UNITED STATES PATENT AND TRADEMARK OFFICE

APPLICATION NO.	FILING DATE	FIRST NAMED INVENTOR	ATTORNEY DOCKET NO.	CONFIRMATION NO.
10/643,406	08/19/2003	Wen Fei Yu	10541-1850	3454
29074	7590	06/20/2006	EXAMINER	
VISTEON C/O BRINKS HOFER GILSON & LIONE PO BOX 10395 CHICAGO, IL 60610			LEO, LEONARD R	
			ART UNIT	PAPER NUMBER
			3753

Office Action Summary

DETAILED ACTION

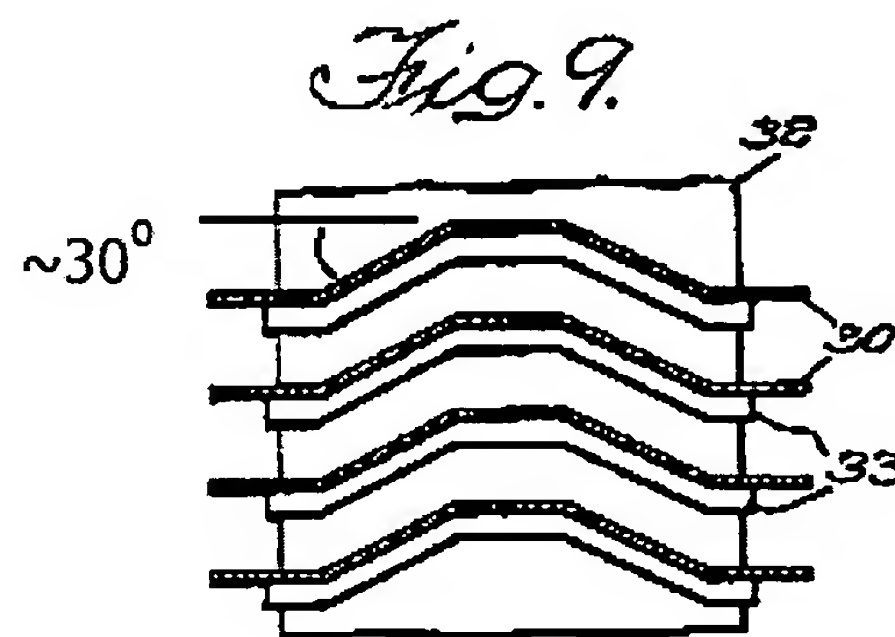
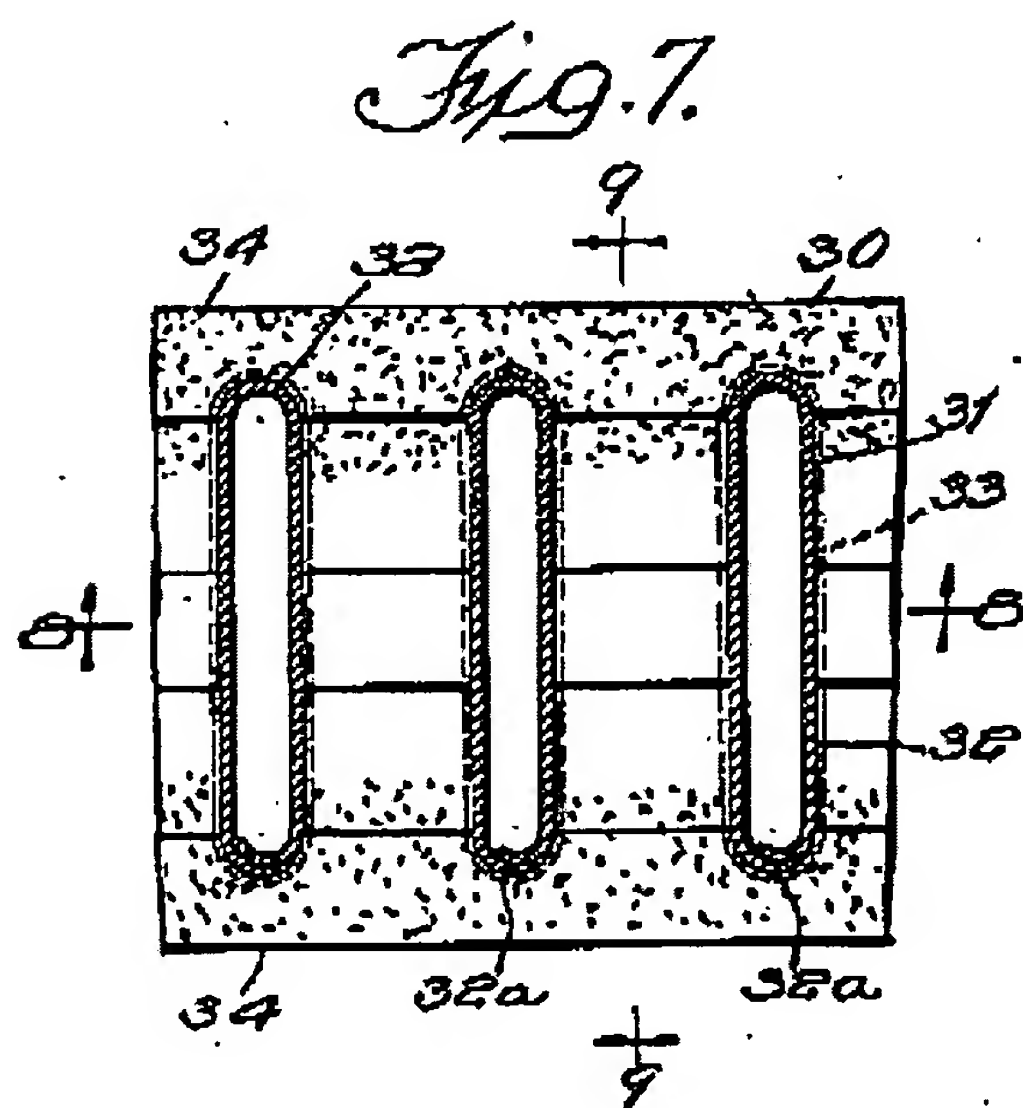
Figure 7 of Modine (1,730,470) discloses a structure having a substantially planar base portion extending laterally (top to bottom) defining a width and longitudinally (left to right) defining a length. Along site line 9-9 of Figure 7, Figure 9 discloses a pair of step portions extending longitudinally along a respective side of the base portion and extending laterally at an angle of about 30 degrees as a straight segment. The recitation of a "header" does not structurally define over the fins of Modine (1,730,470).

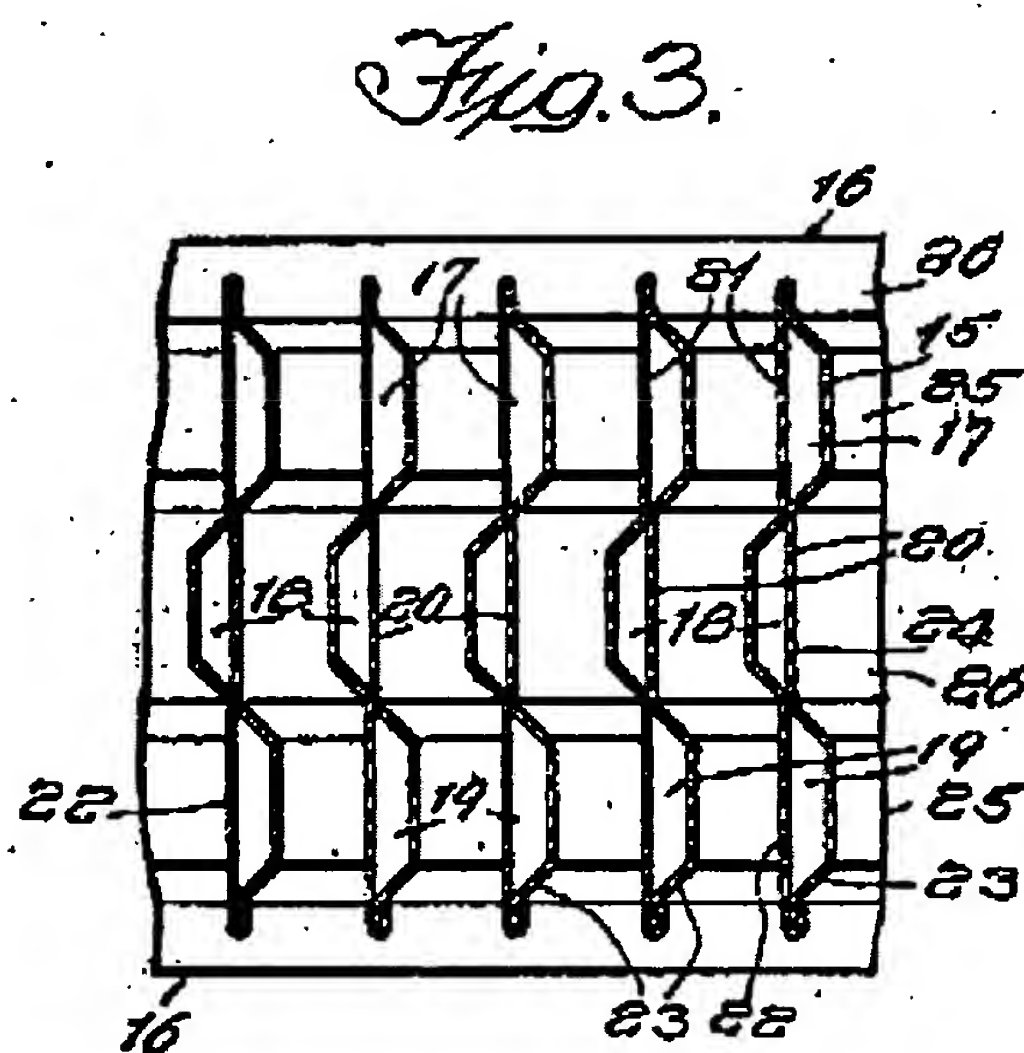
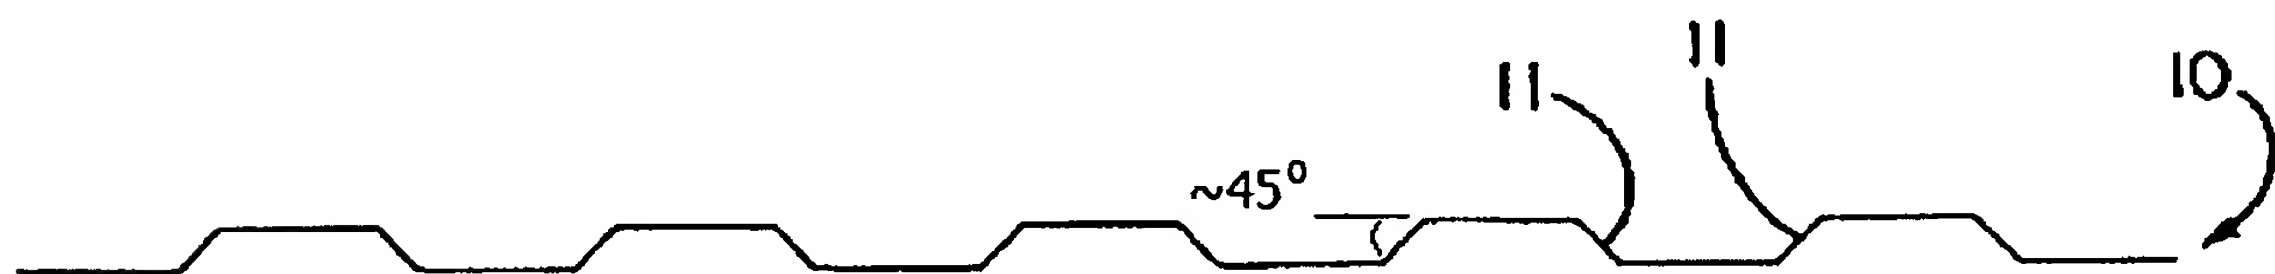
Figure 3 of Modine (1,893,521) discloses a structure having a substantially planar base portion 26 (center) extending laterally (top to bottom) defining a width and longitudinally (left to right) defining a length. In a side view of Figure 3, Figure 2 discloses a pair of step portions (between planar portions 25 and 26) extending longitudinally along a respective side of the base portion 26 (center) and extending laterally at an angle of about 45 degrees as a straight segment. The recitation of a “header” does not structurally define over the fins of Modine (1,893,521).

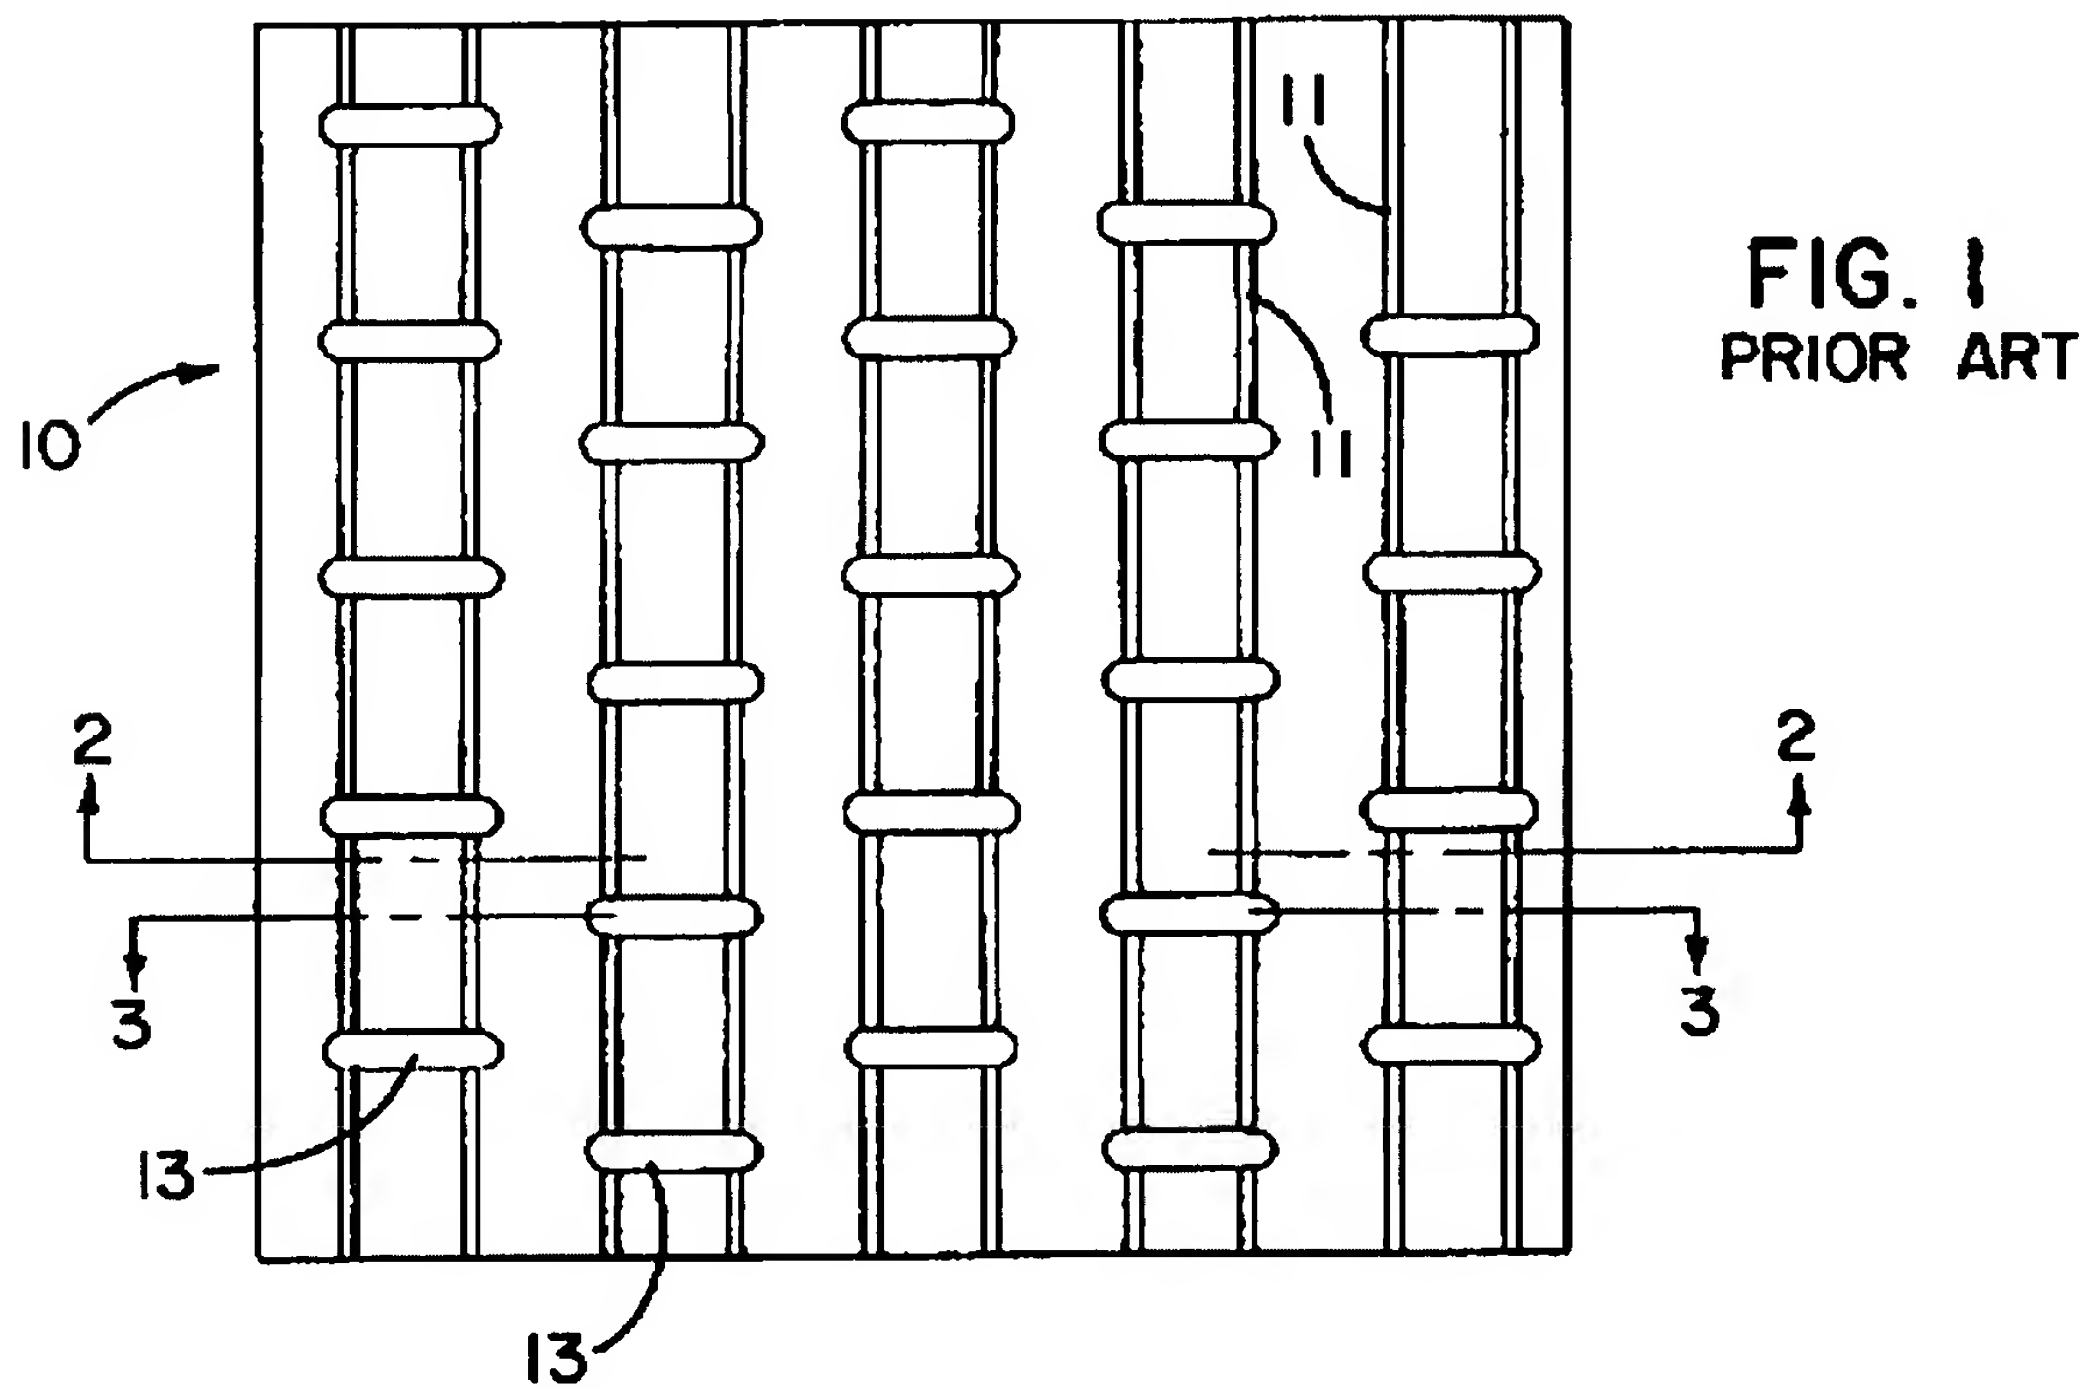
Figure 1 of Hughes et al discloses a structure having a substantially planar base portion extending laterally (left to right) defining a width and longitudinally (top to bottom) defining a length. Along site line 2-2 of Figure 1, Figure 2 discloses a pair of step portions 11 extending longitudinally along a respective side of the base portion and extending laterally at an angle of about 45 degrees as a straight segment. The recitation of a "header" does not structurally define over the fins of Hughes et al.
